Triumph Motorcycles Notice : Service Bulletin 325 - Updated status to Recall**Notice Information**

Please Post**TO:** All Triumph America Dealers**ATTN:** Service Manager / Technicians**SUBJECT:** Safety Recall – Starter Motor / Oil Cooler Pipe – Service Bulletin 325

Service Bulletin 325

Subject Starter Motor Cable/Oil Cooler Pipe

1. Oil cooler return pipe
2. Starter motor power supply cable

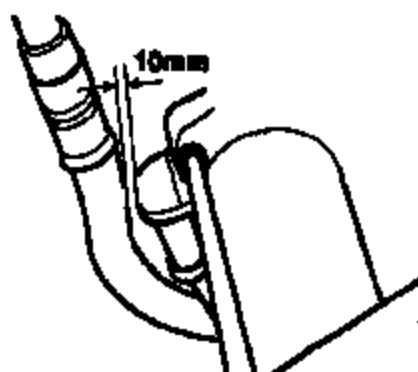
1. Examine the power supply cable to the starter motor for signs of contact with the oil cooler return pipe. If contact is apparent, or if the space between the two items is less than 10 mm, the starter cable and/or oil cooler pipe must be repositioned and any insulation damage rectified.

2. If the gap is found to be at least 10 mm, no further action is necessary. If the gap is less than 10 mm, make adjustments as follows:

3. Disconnect the battery, negative (black) lead first.
4. Ease the cover from the starter motor cable, slacken the cable securing nut and position the cable such that a 10mm gap exists between the oil cooler pipe and the starter cable.
